## Mack MMD Alternator Pulley

Mack Trucks has determined that certain Medium Duty Trucks may have an incorrect Alternator Pulley. On affected vehicles the alternator pulley has the incorrect groove pitch which may cause premature belt wear and in some instances the belt can slip off. To correct this issue the alternator pulley will need to be replaced with an updated part and a new alternator belt installed.

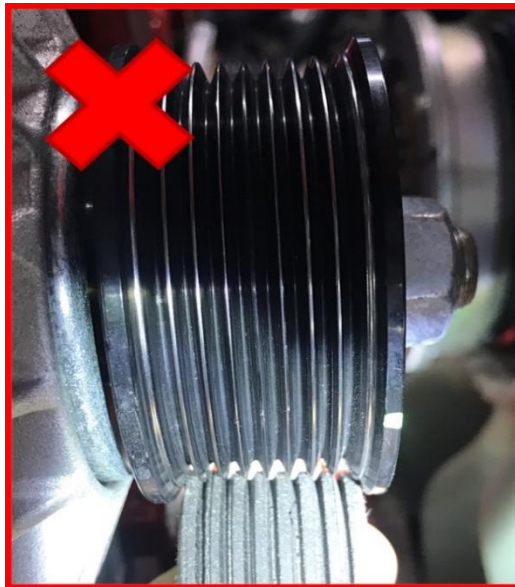
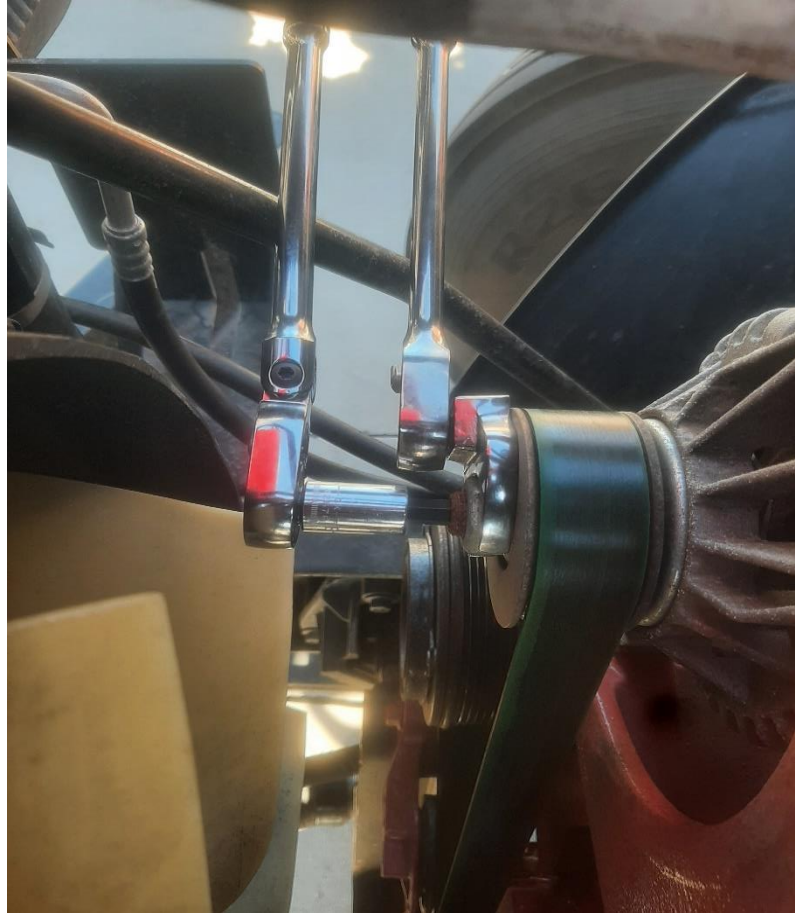
Incorrect

Correct

6. Remove alternator pulley and install new pulley part# **78635625**.
7. Install pulley retaining nut and hand tighten and ensure the pulley is fully seated.
